ECE/TRANS/WP.29/2006/92
9 August 2006

PROPOSAL FOR SUPPLEMENT 10 TO REGULATION No. 87

(Daytime running lamps)

Submitted by the Working Party on Lighting and Light-Signalling (GRE)

MINIMUM ANGLES REQUIRED FOR LIGHT DISTRIBUTION IN SPACE

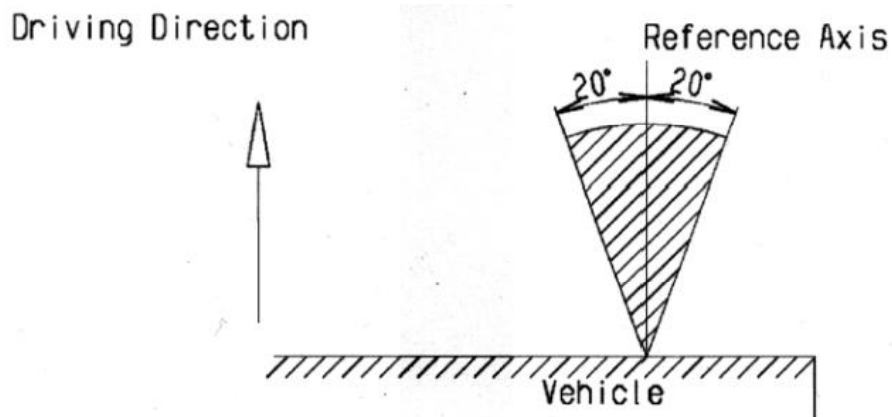
Insert a new Annex 7, to read:

In all cases, the minimum vertical angles of light distribution in space are 10° above and 5° below the horizontal for DRL devices included in the Regulation.

Minimum horizontal angles of light distribution in space:
